Interactive comment on “Homogenizing and Estimating the Uncertainty in NOAA’s Long Term Vertical Ozone Profile Records Measured with the Electrochemical Concentration Cell Ozonesonde” by Chance W. Sterling et al.

Anonymous Referee #3 The authors would like to thank the referees for the constructive criticism of our manuscript. We have outlined our responses to the reviewers’ comments as well as the subsequent changes to the manuscript in the following response. Received and published: 1 January 2018

Fig. 1. Figure 1: The eight long-term NOAA ozonesonde stations with Latitude, Longitude, # of Profiles, and launch period.

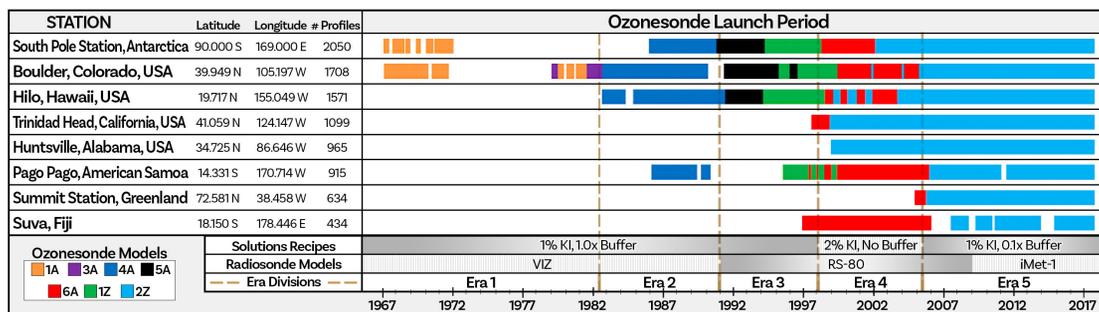
or lower characters throughout the text. Authors' Response: All instances where the name of a particular solution is being discussed have been changed to upper case letters such as 1% KI, 1.0 x Buffer Solution. When discussing buffering agents or the secondary buffer reaction, buffer was changed to lower case characters. 8. P10L10+: Get the subscript depths right. Authors' Response: Corrected in manuscript. 9. P12,13 Equations 8-13: Add unit "K". Authors' Response: The sentence on what is now Page 12 Line 19 has been updated to read, "All temperatures used in calculating ozone are in Kelvin. The pump temperature (T_P) is calculated by adding the differences between configurations and inside of the pump block ($\Delta T_{(P,CIB)}$), and the difference between the inside of the pump block and the internal piston temperature ($\Delta T_{(P,CIP)}$) to the raw pump temperature measured ($T_{(P,Meas)}$) with Eqn. 7." 10. P12L21, P17L23: "degree" is not part of the unit Kelvin. Please delete. Authors' Response: Corrected in manuscript. 11. P13L1: Exchange "truest" by "best estimate of the". Authors' Response: Corrected in manuscript. 12. P16L14,17: Please use "i ĘZA A" instead of "microamps". Authors' Response: All instances of "microamps" has been changed to μA throughout manuscript. 13. P16L20: Please use "cm**3" instead of "cc". Authors' Response: "cc" changed to cm3 throughout manuscript. 14. P16L22: Check place of equation number. Authors' Response: Corrected in manuscript. 15. P17L26,27,28: Add "estimated" before temperature, e.g. "estimated 1.0 K". Authors' Response: Corrected in manuscript. 16. P17L28: Add a space between "0.5" and "K". Authors' Response: Corrected in manuscript. 17. P20L8: Delete on "and". Authors' Response: Corrected in manuscript. 18. P20L9: Add ". . . average DIFFERENCES of the . . ." Authors' Response: Corrected in manuscript. 19. P20L23 & Figures S5-S8: I assume the captions for S5-S8 mentioning Dobson instead of SBUV are wrong. Authors' Response: Yes, the captions should read SBUV instead of Dobson, except for Figure S6 as the South Pole does not have SBUV data. All captions except for Figure S5 are corrected in manuscript. 20. P21L4: "Figures 11 and S7" Authors' Response: Corrected in manuscript. 21. P21L7: "(Figure 13)" instead of "(Figures 8 & 9)" Authors' Response: Corrected in manuscript. 22. Figure 1: What is the meaning of a longitude

of 169 (East of West?) at a latitude of -90. Please add East and North units. Authors' Response: Figure 1 has been updated. The latitude and longitude now include East and North units. 23. F1: Good place to mark the different eras graphically. Authors' Response: Figure 1 has been updated to show the eras. 24. F2: Explain large bars at the end of histograms (A) and (B). Authors' Response: The following sentence has been added at what is now Page 9 Line 12 to explain the large bars at the end of the histograms (A) and (B). "In Figure 2 Panels A and B, the large number of backgrounds greater than the scale of the histograms are attributed to erroneous measurements attributed to the degraded ozone destruct filters." 25. F3: Use lower case characters. Authors' Response: Figure 3 has been updated and now reads "Boulder with dry air", "Fiji with dry air", and "Trinidad Head with dry air". 26. Table 3: Add units for second column. Authors' Response: Table has been updated and the second column now includes the units (μA). A new table was added, so Table 3 is now Table 4. 27. F9-12: It would be nice to have the eras mark as in later figures.' Authors' Response: Figures 9-12 have been updated to include the era marks. 28. F13-15: The relation layer to panel character is somewhat hidden. Please repeat in the caption. Authors' Response: To make the relationship between the panels, layers, and processing more clear, the captions in Figures 13-15 have been changed and now reads "Percent difference in column ozone between the merged SBUV ozone data and the ozonesonde data at Boulder, CO. Panels E and F show Layers 1-8 (Surface - 25.45 hPa), Panels C and D show Layer 9 (25.45 - 16.06 hPa), and Panels A and B show Layer 10 (10.13 - 16.06 hPa). Panels A, C, and E show before and Panels B, D and F show after applying the ozone sensor efficiency." 29. F13-15, FS1-8: Explain colour code. Authors' Response: The different colors in the plot represent different ozonesonde types. This is shown in the legend and is consistent with all of the comparison plots.
